INDESIT company

RA27IXFR

F028853

Notices

n1025118: French products temperature indicator

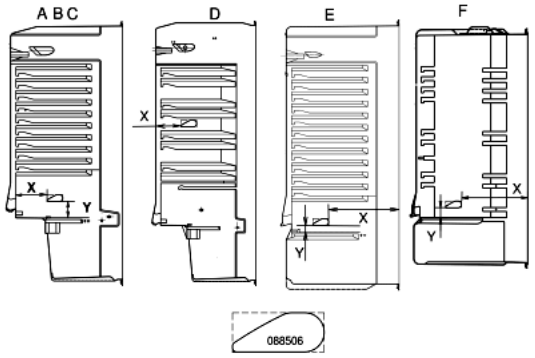
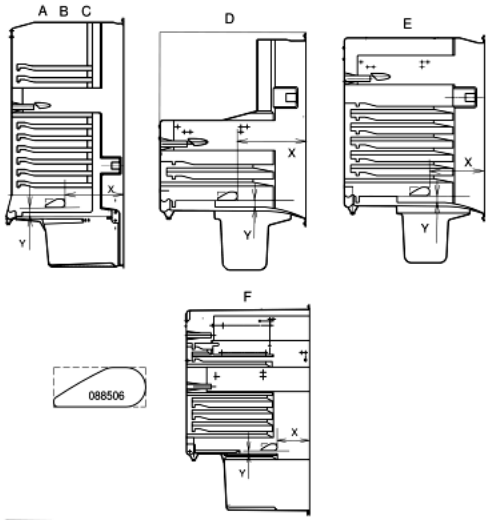
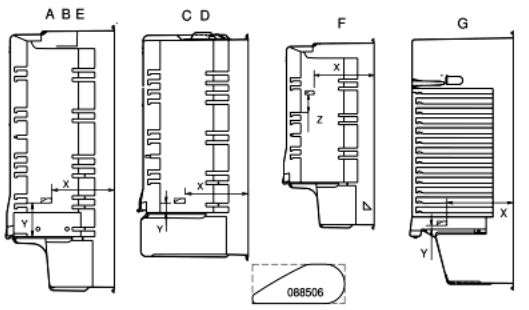
Since April 2002 (serial no. 20404.0001) the Melano, Carinaro and Setubal factories have been fitting the temperature indicator "for better and precise identification of the coldest area inside the refrigerator compartment", on free-standing products intended for the French market.
The temperature indicator, code 088506, consists of a zamak casing fitted with a temperature-sensitive liquid crystal disk. (see see NT008400). On the back of the zamak casing there is a biadhesive for sticking it to the refrigerator cabinet, after carefully cleaning the application area with a heptane-based degreasing product (or similar suitable product).

"OK" must appear on the indicator (correct lighting will enable better reading of the indicator).
If the indicator appears completely black, this means that the average temperature of the area is too high (higher than +4°C). In this case the temperature must be decreased (colder) by operating the device that controls temperature inside the refrigerator. With each change, wait for the temperature inside the refrigerator compartment to stabilize (approx. 10hr) before doing another adjustment.

1.Value (X) indicates the distance from the rear wall
2.Value (Y) indicates the distance from the top of the crisper lid
3.Value (Z) refers to the top of the glass shelf on the third guide from the top.

n1025157: New central hinge for Indesit-55 2-door 240 litre refrigerators (Carinaro)

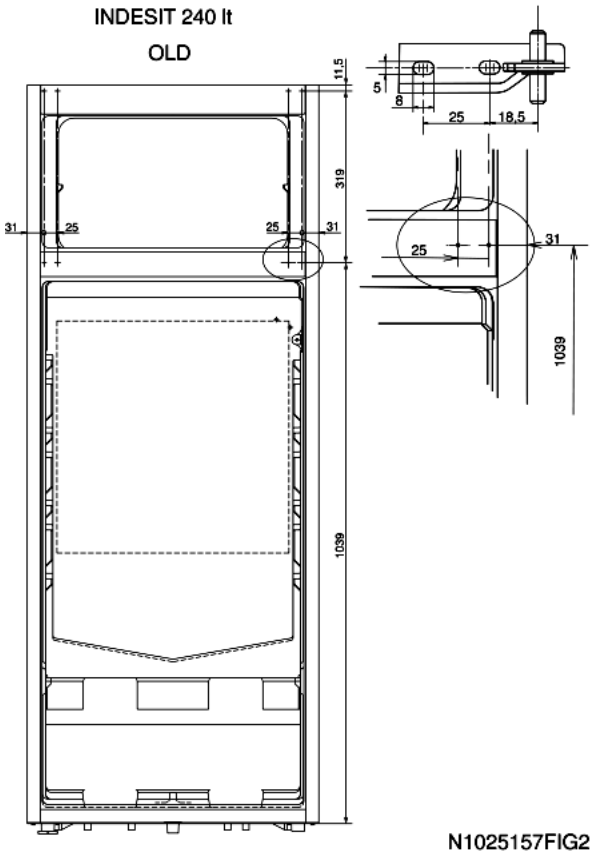
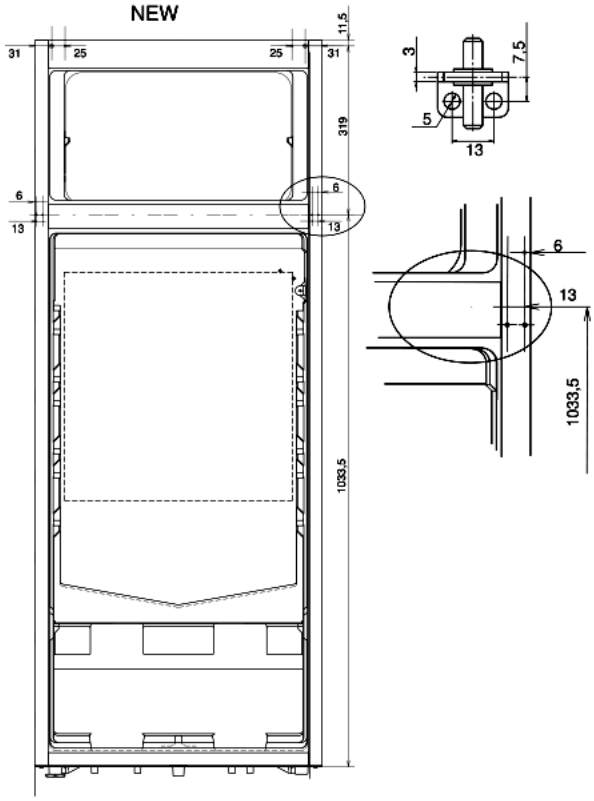
From serial no. 60123.0001 the Carinaro factory has modified the body of the 240 litre refrigerator by introducing a new central

hinge (see figure N1025058 Fig.1) secured to the side panel. In addition, the height of the refrigerator door has been reduced from 1030 to 1028 mm.
This hinge is still reversible but it cannot be fitted on premodification models, on which the hinge was attached to the central trim of the refrigerator cabinet (see figure N1025157fig2).
When changing the door opening from right to left, the new hinge does not need to be inverted like the previous one, just moved to the left side.
To fix the hinge drill a hole on the left side of the refrigerator cabinet (see figure N1025157fig3).

NB - 1028 mm high doors can be fitted to premodification models by using a 2 mm washer (028928 - 034618 - 036775) on the lower hinge.

141794 - POLAR WHITE CENTRAL HINGE (CARINARO)
142756 - CHROME-PLATED CENTRAL HINGE
143328 - REFRIGERATOR DOOR ROUNDED-STYLE/TEAK 540X1028X55 GIUGIARO
143327 - REFRIGERATOR DOOR ROUNDED-STYLE/SILVER 540X1028X55 GIUGIARO
143326 - REFRIGERATOR DOOR ROUNDED-STYLE/S.STEEL 540X1028X55 GIUGIARO
143325 - REFRIGERATOR DOOR ROUNDED PW 540X1028X55 GIUGIARO

053838 - CHROME-PLATED CENTRAL HINGE
053478 - WHITE CENTRAL HINGE
114624 - POLAR WHITE CENTRAL HINGE
084826 - REFRIGERATOR DOOR ROUNDED-STYLE/TEAK 540X1030X55 GIUGIARO
083820 - REFRIGERATOR DOOR ROUNDED-STYLE/SILVER 540X1030X55 GIUGIARO
094790 - REFRIGERATOR DOOR ROUNDED-STYLE/S.STEEL 540X1030X55 GIUGIARO
141581 - REFRIGERATOR DOOR ROUNDED-STYLE/PW 540X1030X55 GIUGIARO

n1025158: New central hinge for Ariston-55 2-door 240 litre refrigerators (Carinaro).

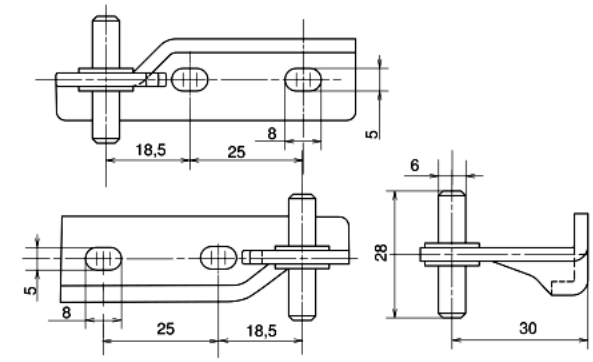
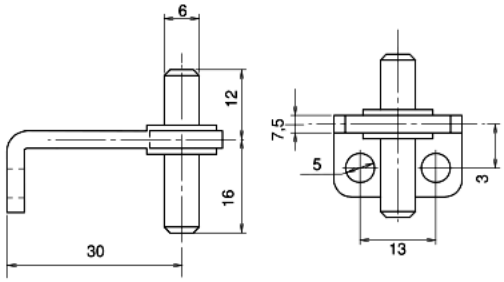
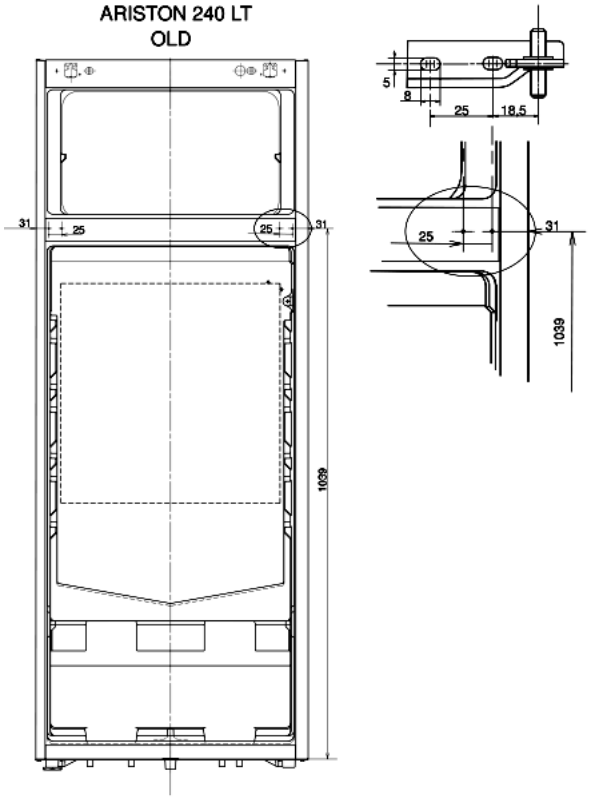
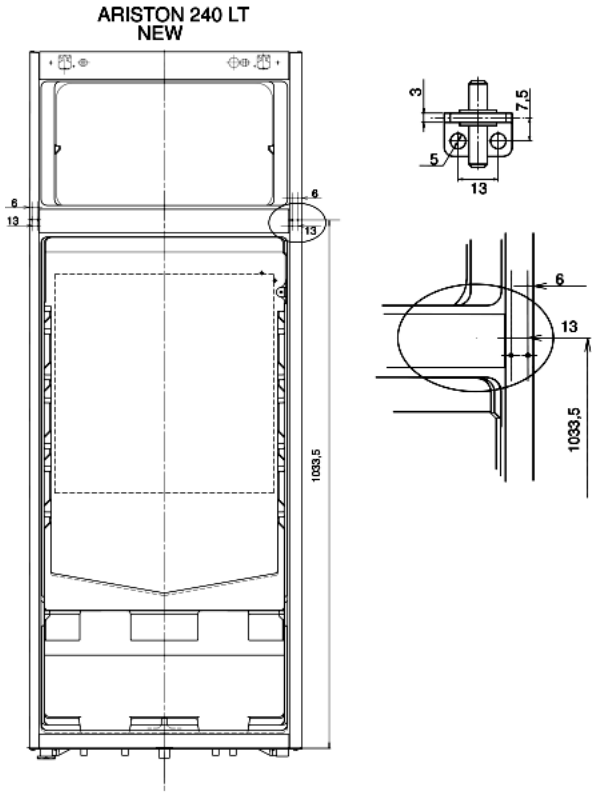
From serial no. 60123.0001, the Carinaro factory has modified the body of 240 litre refrigerators by introducing a new central hinge (see figure N1025058 Fig.1) attached to the side panel.
This hinge is still reversible but cannot be fitted on premodification models where the hinge was attached to the central trim of the refrigerator body (see Figure N1025058fig2).
When changing the door opening from right to left, the new hinge does not need to be inverted like the previous one, just moved to the left side.
To secure it, a hole must be made on the left side of the refrigerator body (see figure N1025058fig3).

141794 - POLAR WHITE CENTRAL HINGE (CARINARO)
142756 - POLAR WHITE CENTRAL HINGE (MANISA)
142756 - CHROME-PLATED CENTRAL HINGE

053838 - CHROME-PLATED CENTRAL HINGE
053478 - WHITE CENTRAL HINGE
114624 - POLAR WHITE CENTRAL HINGE

OLD 053838 - 053478 - 114624

NEW 141794 - 142760 - 142756
